17. Appendix G – Pre Application Minutes

Record of a pre-application meeting

Street number and name:	12 Lakewood Court
Suburb, town or locality:	Manukau

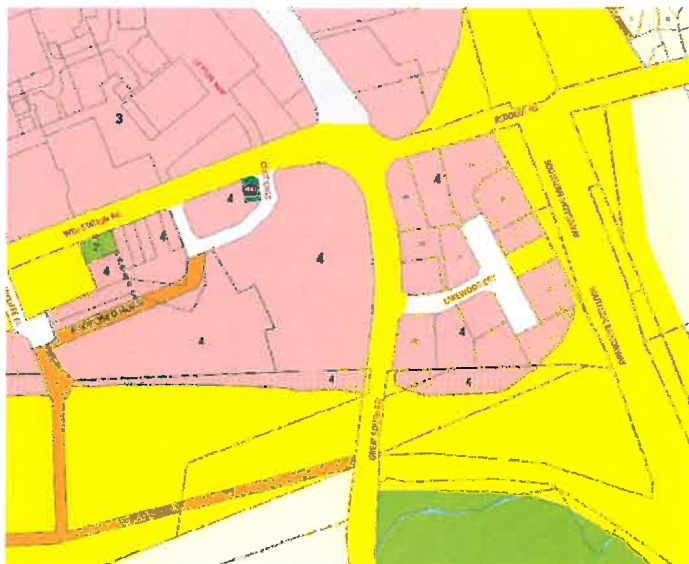
Business 4 Zone requires a 7.5m front yard setback from all road frontages.
A motorway is also a road (in yellow.)

Height in relation to all road frontage boundaries is required. Whilst this appears to have been achieved to Redoubt Road in terms of HIRTB, it has not been achieved in relation to the eastern road boundary to the motorway.

Also not sure if 7.5metre yard has been met to eastern front boundary to motorway.
Need distances shown on the plan for all three points.
